HISTORIC AND DESIGN REVIEW COMMISSION

HDRC CASE NO: 2024-053
ADDRESS: 515 VILLITA ST
LEGAL DESCRIPTION: NCB 142 BLK LOT 11
ZONING: D, H, RIO-3
CITY COUNCIL DIST.: 1
DISTRICT: La Villita Historic District
APPLICANT: Samuel Panchevre/Alamo City Investments
OWNER: San Antonio Conservation Society Panchevre/Casa Catrina
TYPE OF WORK: Construction of trellis structures on the river side, installation of vinyl graphics, installation of murals, installation of an altar within flower bed
APPLICATION RECEIVED: January 24, 2024
60-DAY REVIEW: March 24, 2024
CASE MANAGER: Edward Hall

Historic and Design Review Commission
Design Review Committee Report

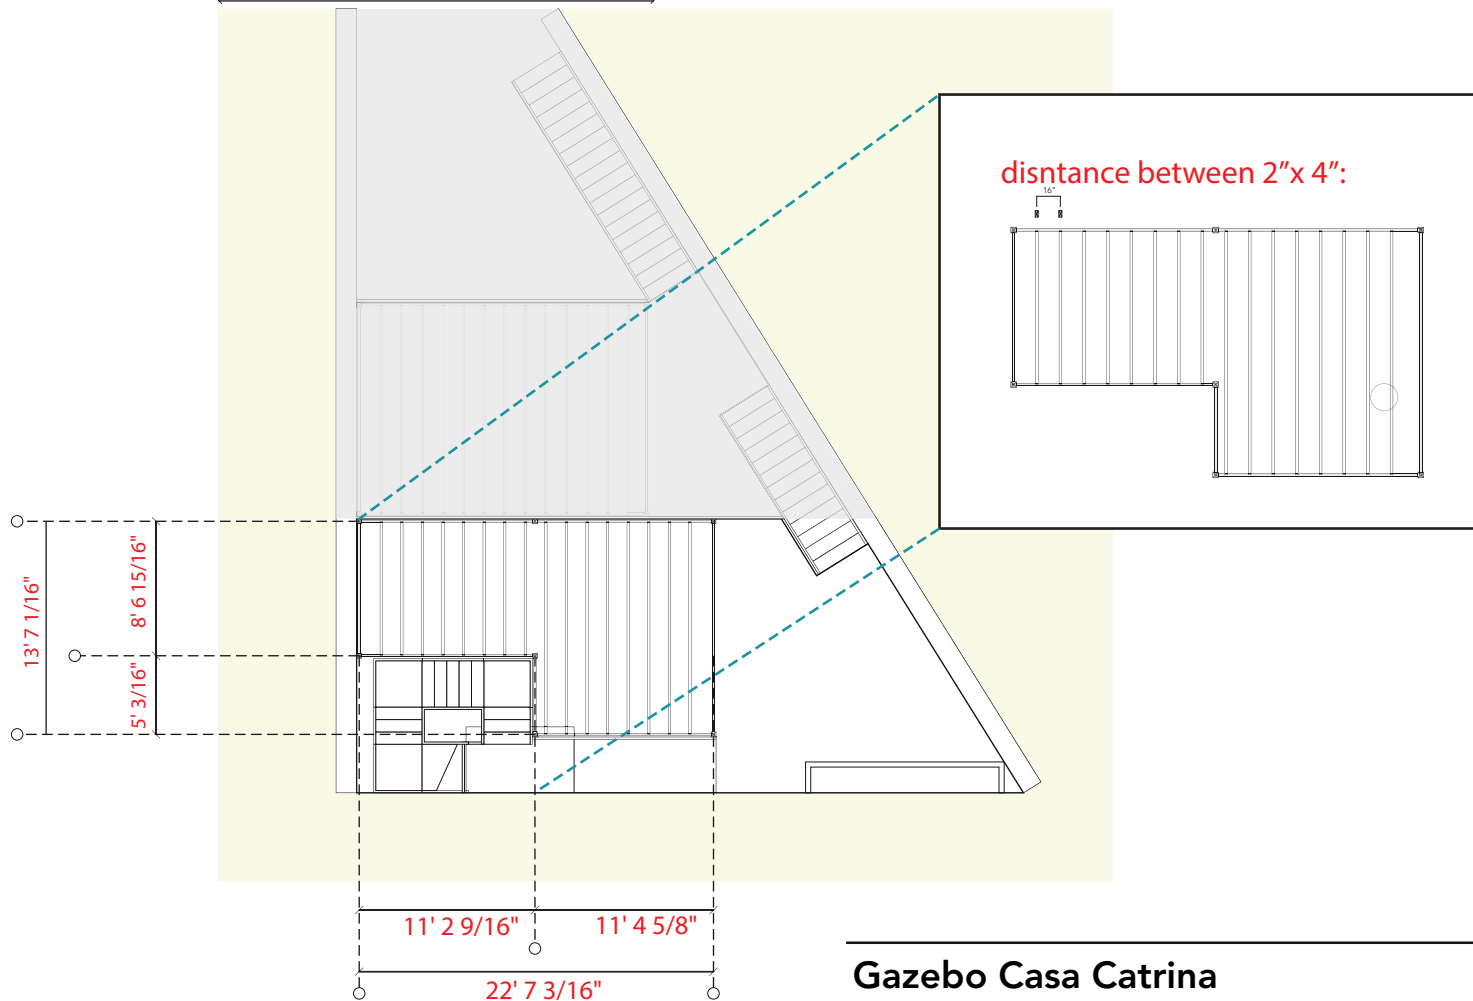
SP: Question regarding concern of trellis

SP: Trellis has been designed to provide an open view from the River Walk to the historic building

MS: Can the next design package include photos with drawn in representations of the trellis (to provide an idea of the massing)? Mock up with wood and photos of that would be sufficient.
